**California Endangered Species Act
Amended Incidental Take Permit No. 2081-2021-015-06
(Amendment No. 5)**

CRIMSON SOLAR PROJECT

CDFW now reissues this ITP including the revised provisions in this Major Amendment (Collectively, the Amended ITP). The Amended ITP includes all of the operative provisions as of the effective date of this Amended ITP. Attachment 11 to this Amended ITP shows the specific red-line changes made to the ITP as a result of this Major Amendment.

Figure 2
Updated Project Fencelines and Phasing

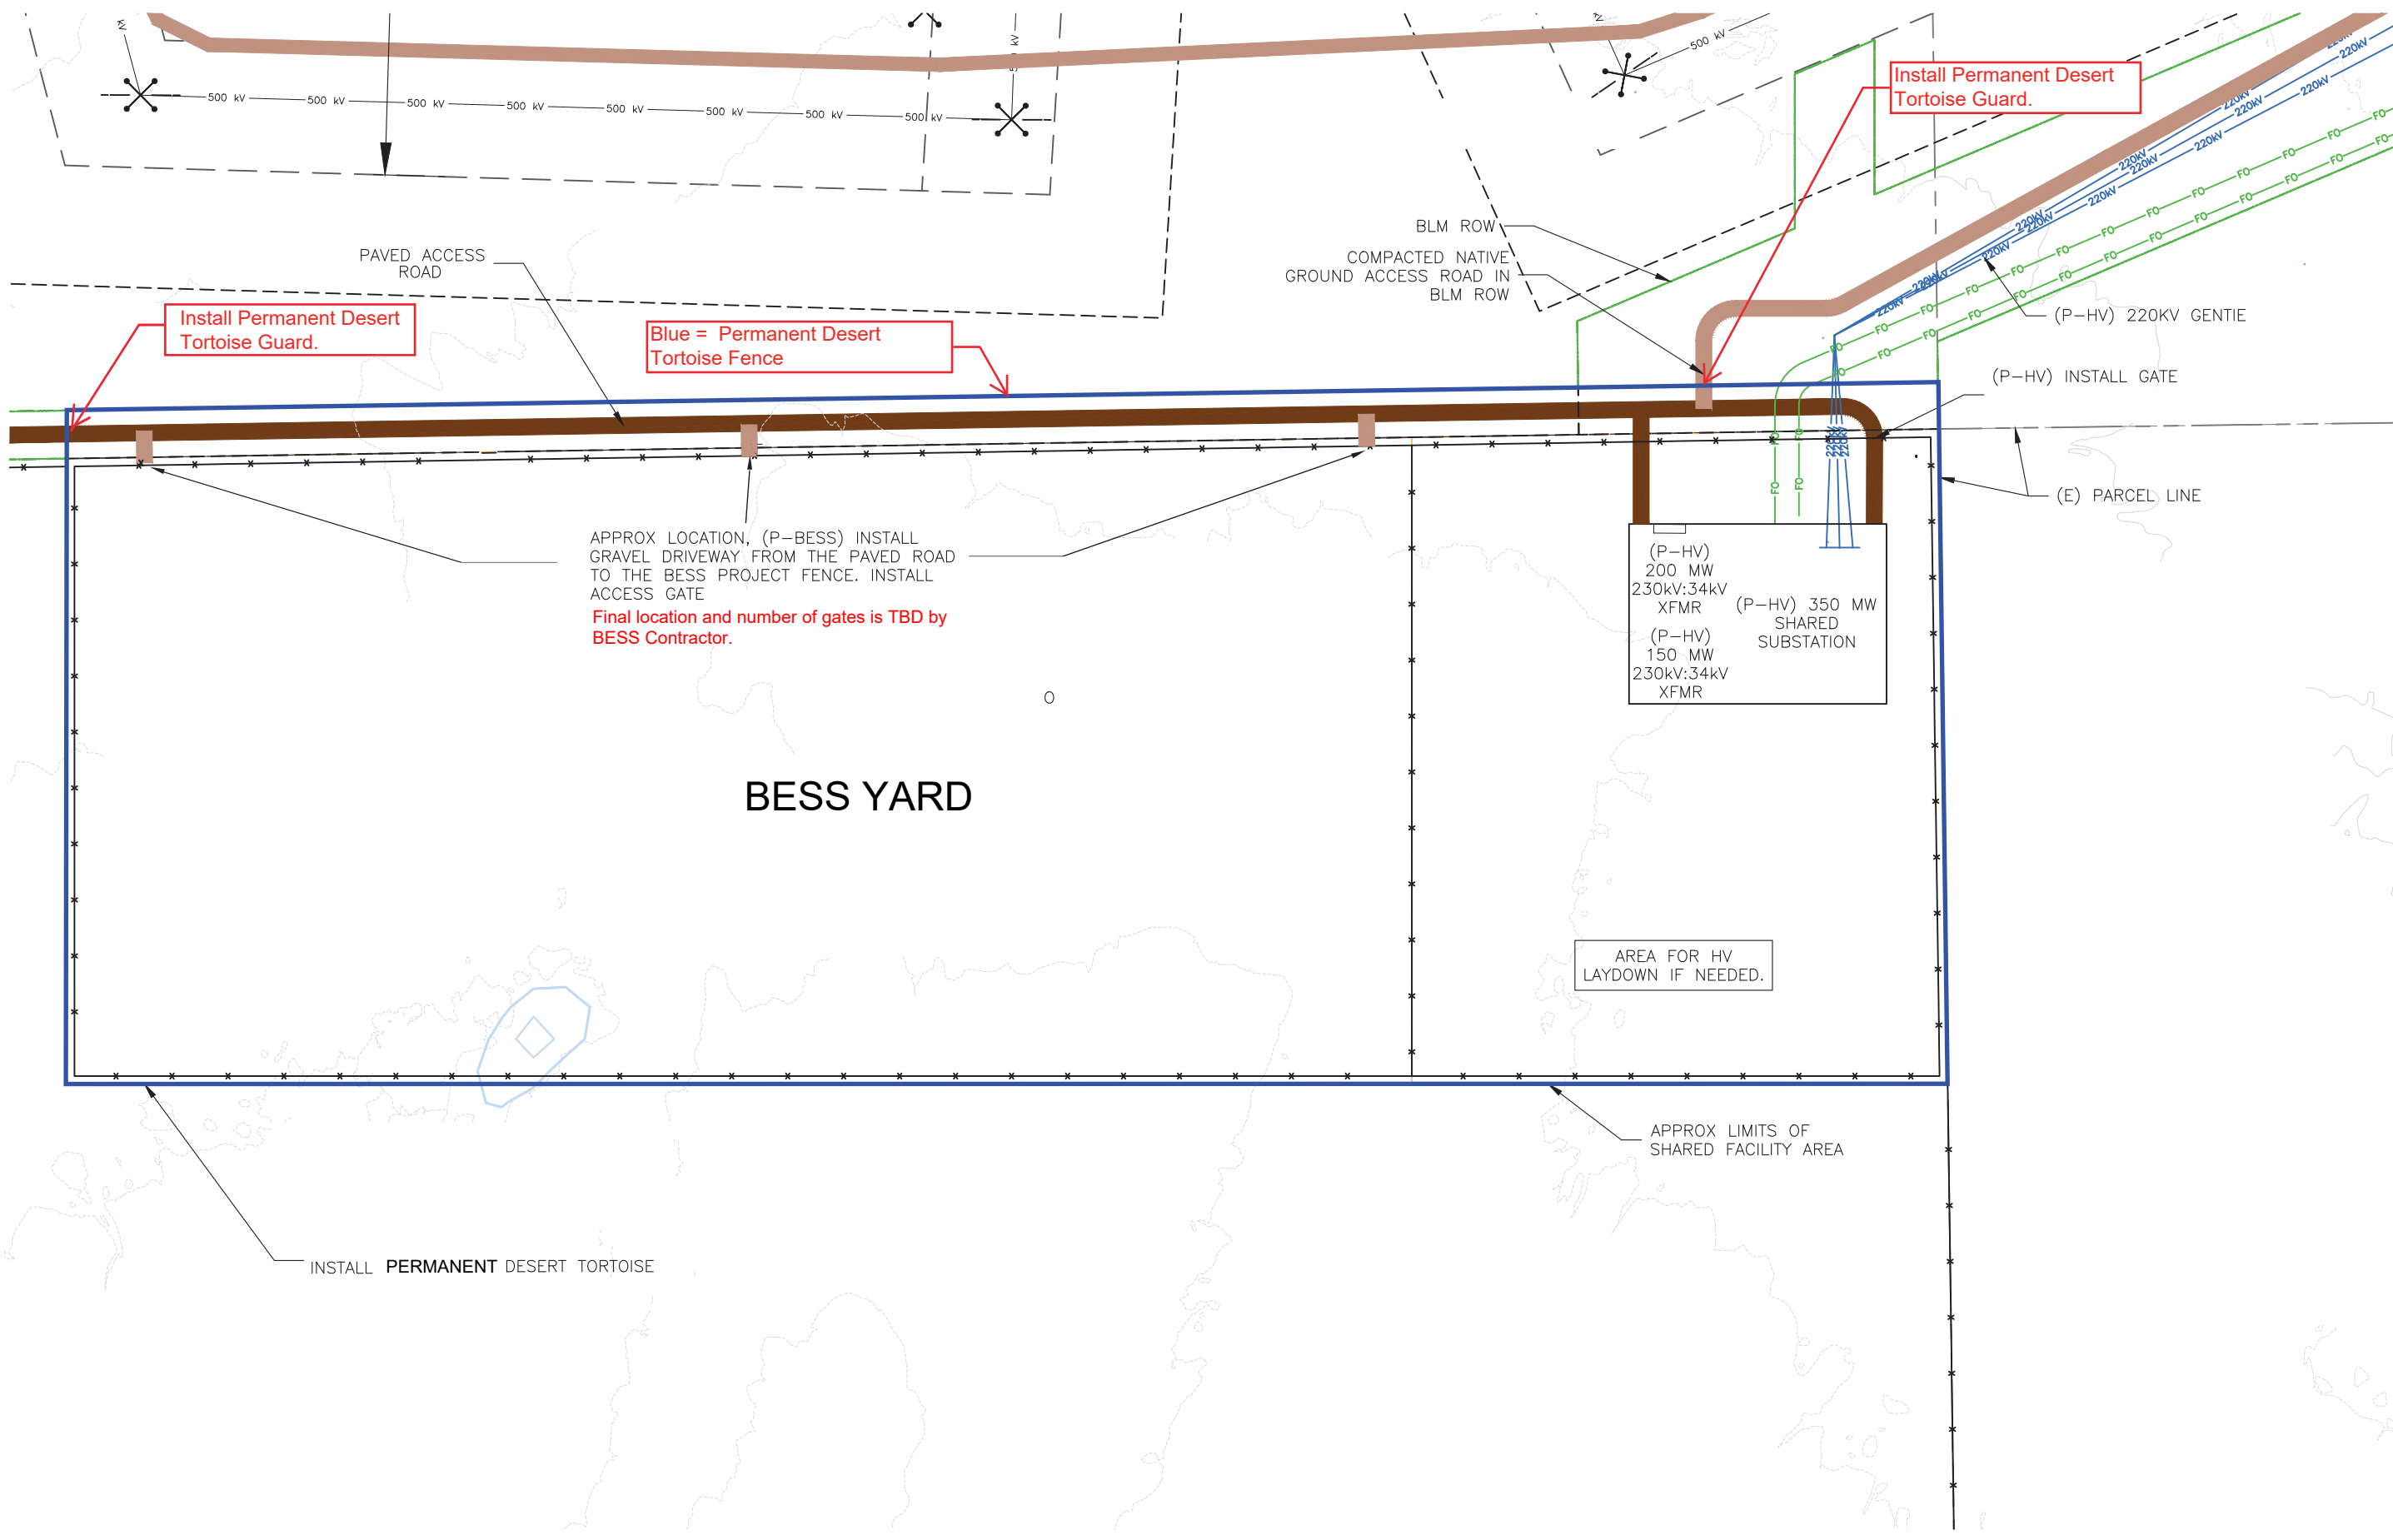
- 1. Phase 2 and its impact acreage were expanded and split into subphases: Phase 2A and Phase 2B. Phase 2A contains the former Phase 2 area, and Phase 2B contains the Solar Facility previously associated with Phase 3 (see Amended Figure 2). The acreage impacted in Phase 2A is 1,195.1, and the acreage impacted in Phase 2B is 679.0.
- 2. The mega-wattage produced by the Phase 2 Solar Facility was increased from 150MW to 250MW, while the megawatt-hours stored by the BESS decreased from 1,400MWh to 1,000MWh.
- 3. Phase 3 no longer contains the Solar Facility and was moved to the north of the Project Area, thus reducing its impact acreage to 33.0 for the BESS. Perimeter fencing was added around the BESS.

1. Phase 2 and its impact acreage ~~werehas been~~ expanded and split into subphases: Phase 2A and Phase 2B. Phase 2A contains the former Phase 2 area, and Phase 2B ~~now~~ contains the Solar Facility previously associated with Phase 3 (see Amended Figure 2). The acreage impacted in Phase 2A is 1,195.1, and the acreage impacted in Phase 2B is 679.0.

1 SUBSTATION & BESS FACILITY DETAIL
SCALE: 1"=200'

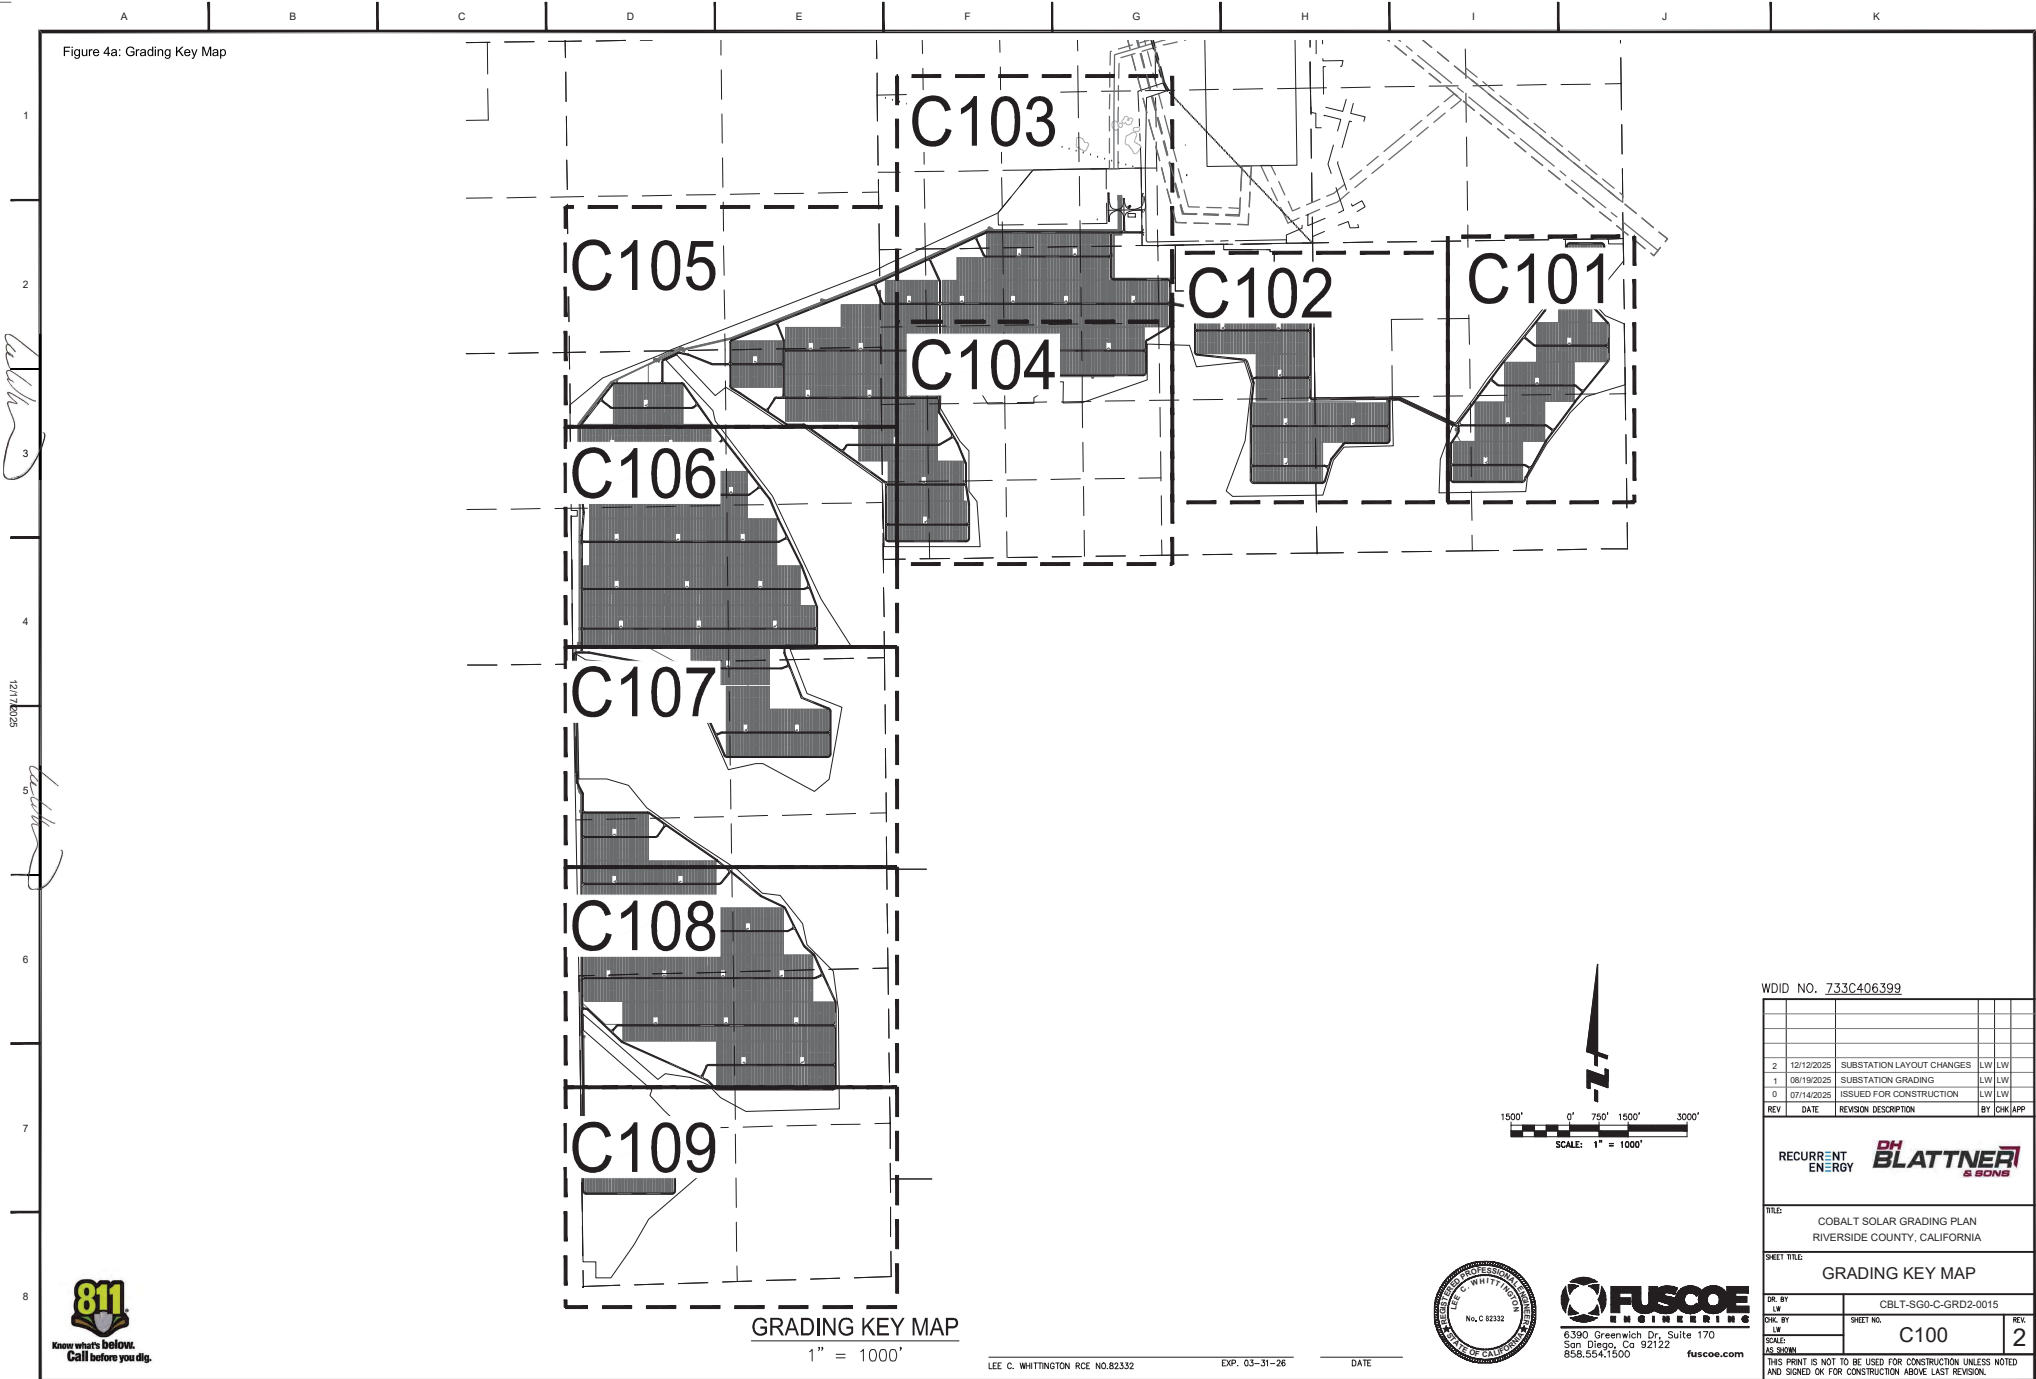
- (3) The Covered Species exclusionary fencing requirements in Condition of Approval 8.14 was amended to allow detached sections of fencing for the Phase 1 surrounding the BESS to bring the Permittee into compliance. The Covered Species exclusion fencing was not attached to the perimeter security fencing as required. Due to the altered design, the requirement of maintaining the detached fence is added.

For Phase 1, the permanent desert tortoise exclusion fencing shall be detached from the north side of the 8-foot-high standard chain link security fencing of the substation and BESS facility. The permanent desert tortoise exclusionary fencing shall be installed on the north side of the access road with permanent desert tortoise guards within the access road where there is a gap for vehicle passage (Figure 3). The desert tortoise exclusionary fencing shall be attached to the 8-foot-high standard chain link security fencing on the east, south, and west sides of the substation and BESS facility.
